14_38 Updating Expressway Gutter Standards

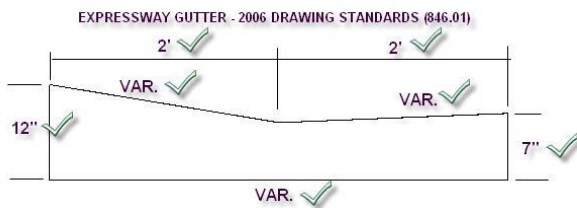
Criteria is drawing expressway gutter with a 6:1 back slope rather than a 4:1 as per Std. 846.01 sht. 1 of 3.

1. Dimensions and slopes of the expressway gutter are from 1998 Drawing Standards. At that time the nominal gutter back slope was 0.17'/1' (or 6:1) and the gutter back depth was 10".

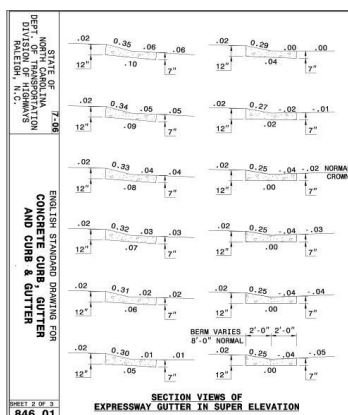
Since then, beginning with the 2002 to the current 2006 Drawing Standards, the nominal gutter back slope is currently 0.25'/1' (or 4:1) and the gutter back depth is set to 12".

2. Current Criteria fixed the expressway gutter back slope to be always 0.17'/1' (or 6:1). Criteria will have to be modified to be in compliance with 2006 Drawing Standards 486.01 Sheet 2 of 3, Section Views of Expressway Gutter in Super Elevation. The gutter base slope, foreslope, and back slope are variable and exclusively DEPENDENT on the superelevation of the proposed pavement. See diagram below.

The Criteria Library (L:\ Drive) has been updated for these required modifications for expressway gutter standards.
